**Preliminary Review Comments
of Century City Area
Fault Investigation Report
Westside Subway Extension Project
Century City and Beverly Hills, CA**

March 8, 2012

Submitted To:
Mr. Aaron Kunz
City of Beverly Hills
345 Foothill Road
Beverly Hills, CA 90210

By:
Shannon & Wilson, Inc.
664 W. Broadway
Glendale, CA 91204

Photograph 1 – South Side of “Big” Santa Monica Boulevard looking southwest along the old railroad right-of-way.

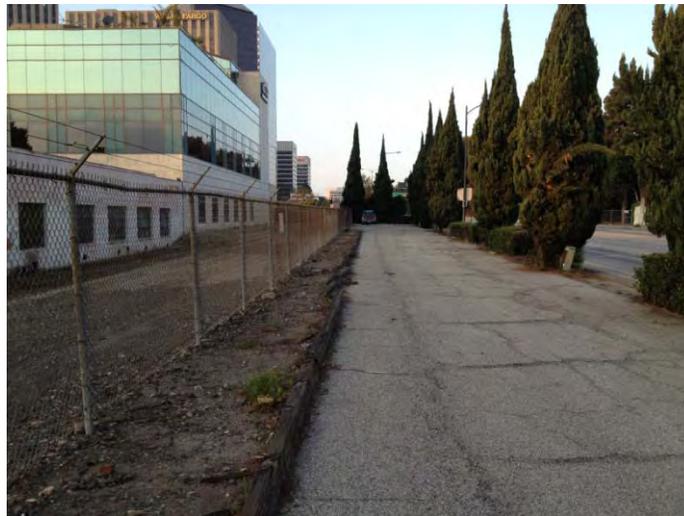
As discussed above, we recommend that additional studies be considered to determine fault activity of the WBHL in the vicinity of Santa Monica Boulevard. An east-west fault trench could be excavated in the old railroad right-of-way on the south side of “Big” Santa Monica Boulevard as shown in Figure 2 and Photograph 1 below, to confirm the WBHL findings at the BHHS. A north-south fault trench perpendicular to the trace of the SMFZ should also be considered at the west end of the proposed station in this area to confirm the termination of the SMFZ at the WBHL. Depending on the results of these additional studies, locating the station within the currently denoted WBHL may be feasible.

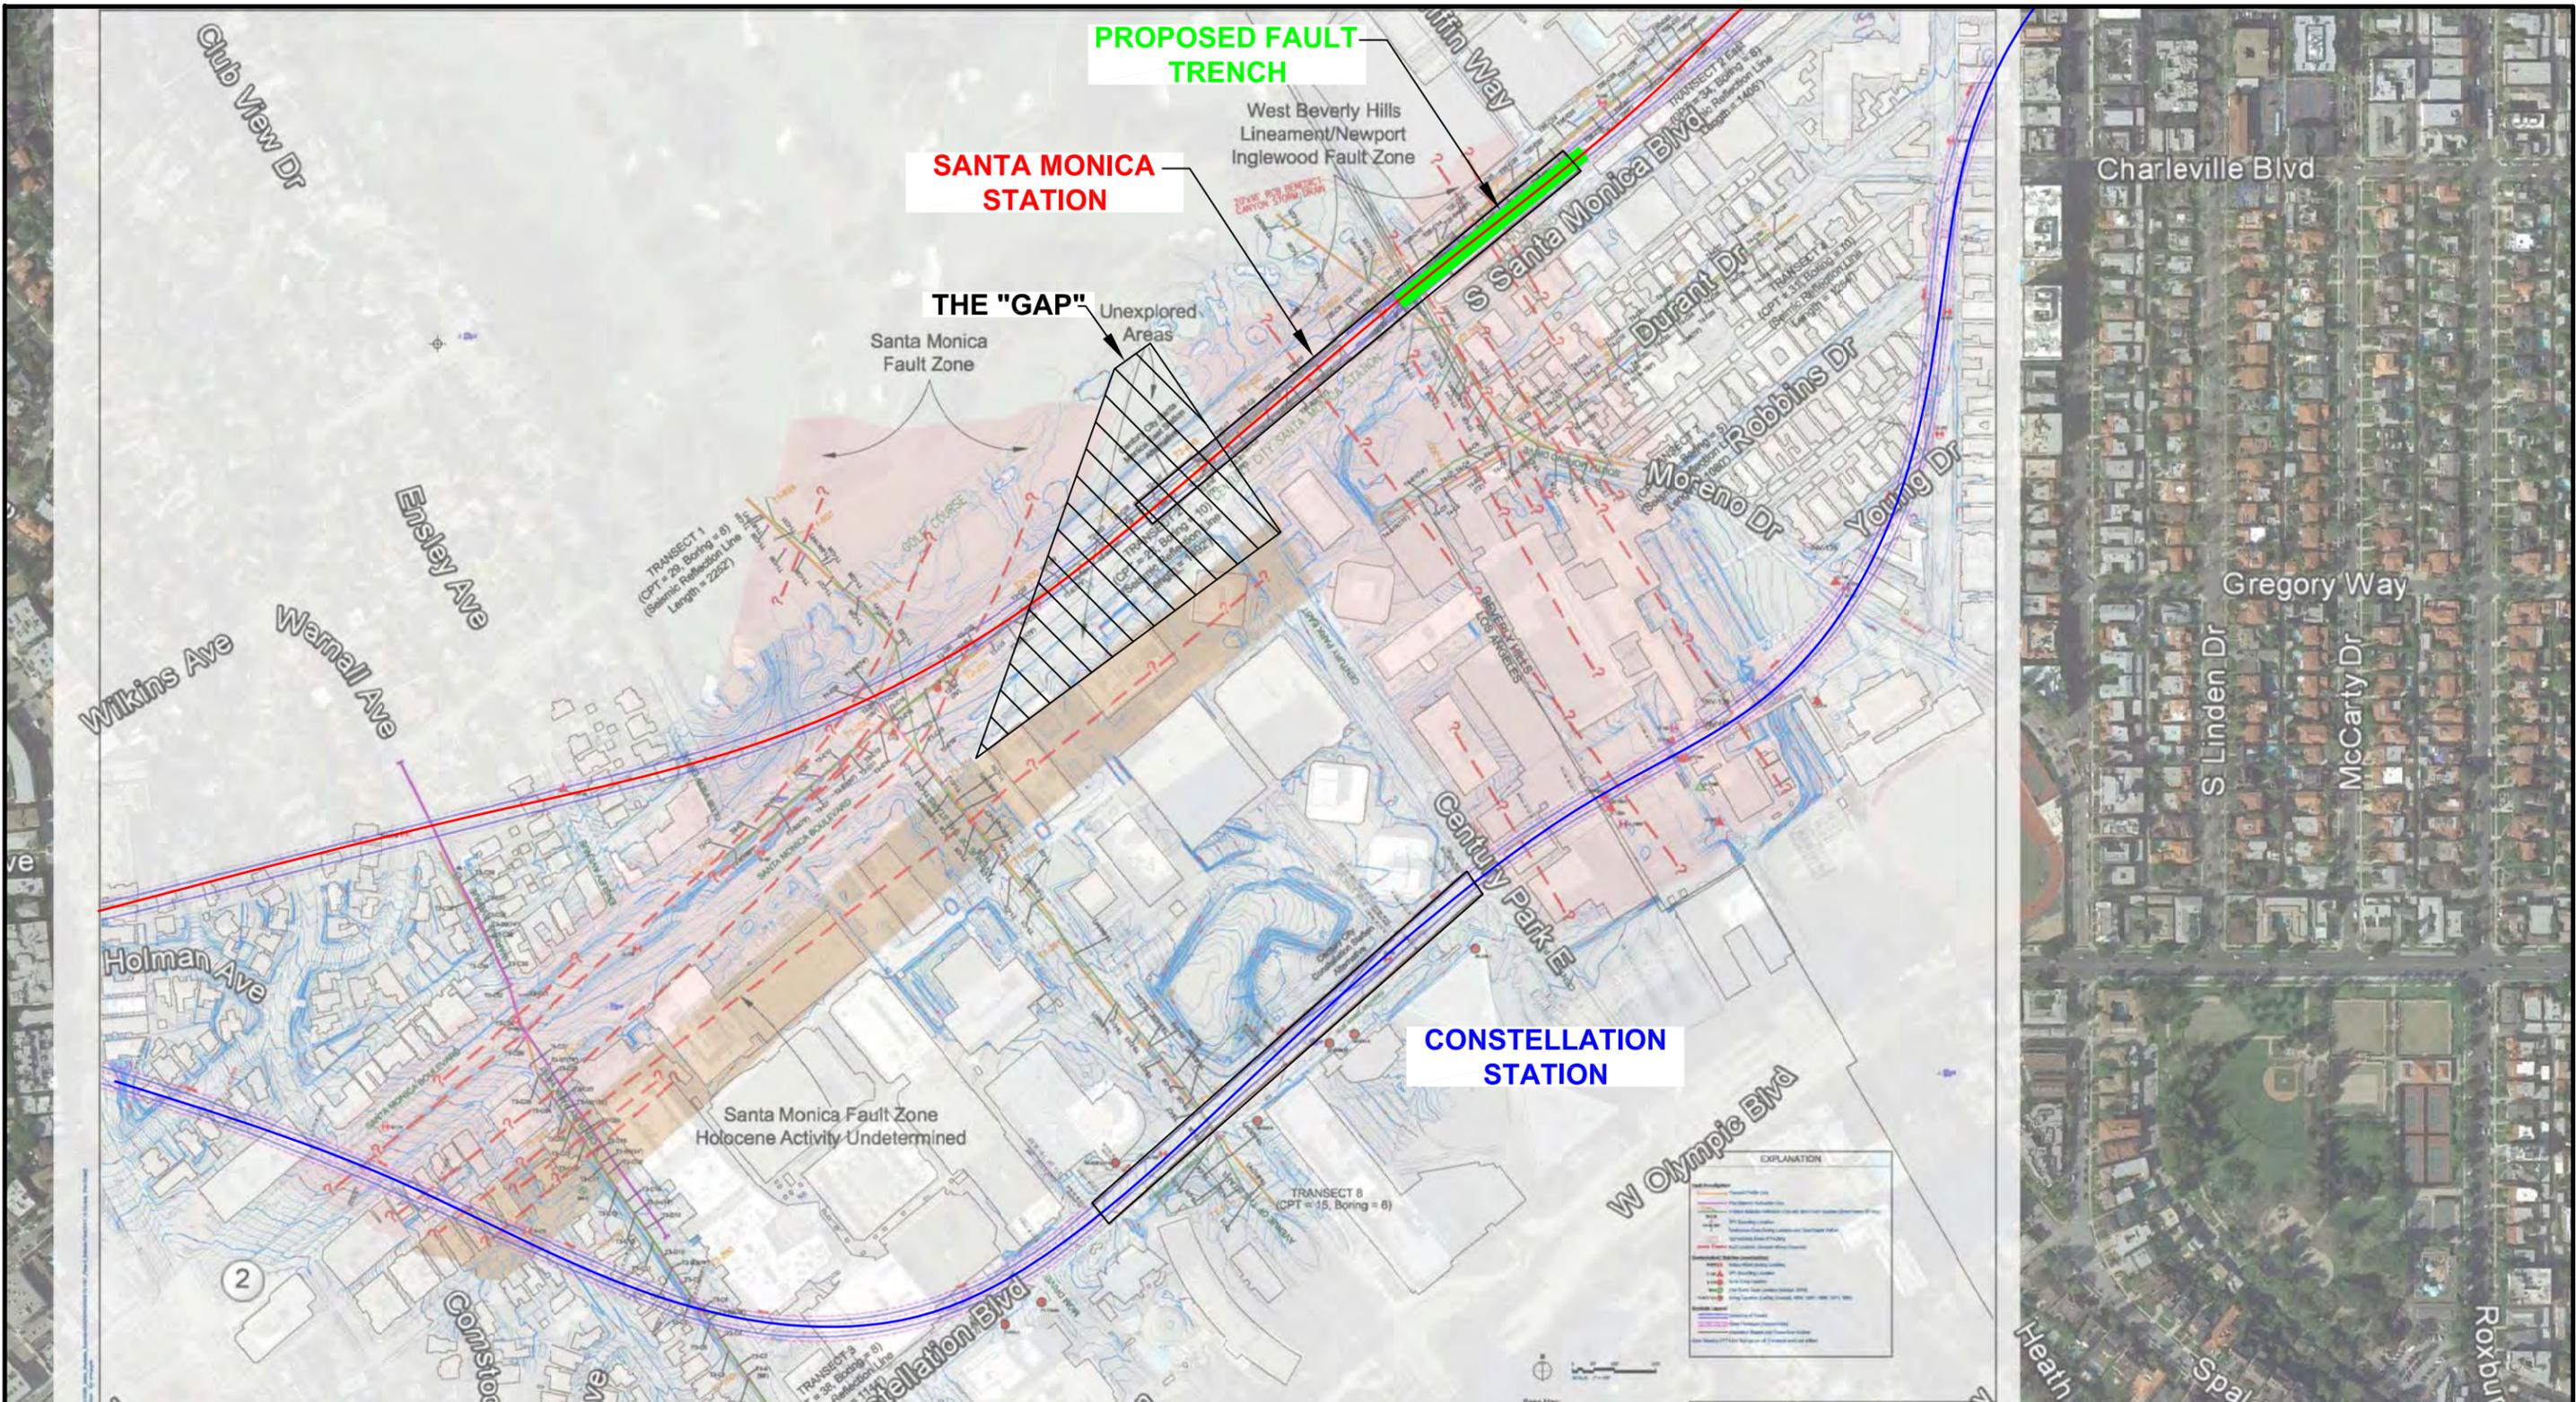
Santa Monica Station Relocation – Relocating the station further south or east along Santa Monica Boulevard, including the gap (see Figure 2) between the Santa Monica Fault Zone (SMFZ) and West Beverly Hills Lineament/Newport Inglewood Fault Zone (WBHL), has risks similar to the current proposed Santa Monica Station owing to high probability of ground deformation stemming from earthquakes originating from the SMFZ or by previously unmapped fault splays. Data collected at the recent fault trenching performed at BHHS, does not appear to indicate that the WBHL is an active fault. Relocating the Santa Monica Station further east as shown in Figure 2 could be feasible if the WBHL is also shown to be inactive where it crosses Santa Monica Boulevard, and if the SMFZ terminates west of the Beverly Hills City Limits. We recommended fault trenching occur at the station location.

As shown in Figure 2, traces of the SMFZ are interpreted to curve northeast near the intersection with the WBHL, leaving a gap between the two faults along Santa Monica Boulevard. However, the apparent curves of the fault traces may be due to topographic

It is uncertain if the main trace of the SMFZ, or a fault splay, lies within the gap, even though maps presented in the Fault Report indicate otherwise. The Fault Report notes that the portion of the SMFZ that bends away from Santa Monica Boulevard is within an area that may have been modified by stream activity. The erosion could have modified the topographic expression of the SMFZ to make it appear that the fault curves to the north, when in actuality it could follow Santa Monica Boulevard in a more straight-line fashion until it intersects with the WBHL. As a result, there is a reasonable chance that the SMFZ crosses the gap.

Moving the station further northeast into the WBHL could be a feasible option based on our interpretation of the Fault Report data and trenching at BHHS. The Fault Report concludes that the WBHL is structurally connected to the active Newport-Inglewood Fault zone to the southeast, and therefore is also considered active. However, the recent trench mapping at the BHHS contradicts this conclusion. Also, the Fault Report geologic sections showing displacements of geologic units by the WBHL (Plate 4 of Fault Report) terminate in the Older Alluvium Sand Deposits (geologic symbol: Qfo). The unit is identified as late Pleistocene (Table 1 of Fault Report), which makes it too old to be an indicator of Holocene fault activity. This is an important issue in deciding if a fault is “active”, which relies on movement within the recent Holocene Epoch (the last 10,000 to 12,000 years).

With tentative reclassification of the WBHL fault splays and zone through the BHHS study area as “in-active”, the extrapolated WBHL features crossing Santa Monica Boulevard to the northwest of the BHHS campus should be further explored to confirm absence or inactivity of fault splays at this location. While the faulting observed at the BHHS trenches is now considered inactive, this does not negate activity in the area of Santa Monica Boulevard due to the presence of the SMFZ. The possible intersection of the likely active SMFZ at Santa Monica Boulevard complicates WBHL activity at this location. Furthermore, fault traces east of the Beverly Hills city limits could be present and/or active as they are further east of the BHHS campus (and thus unexplored by the BHHS fault trenches).
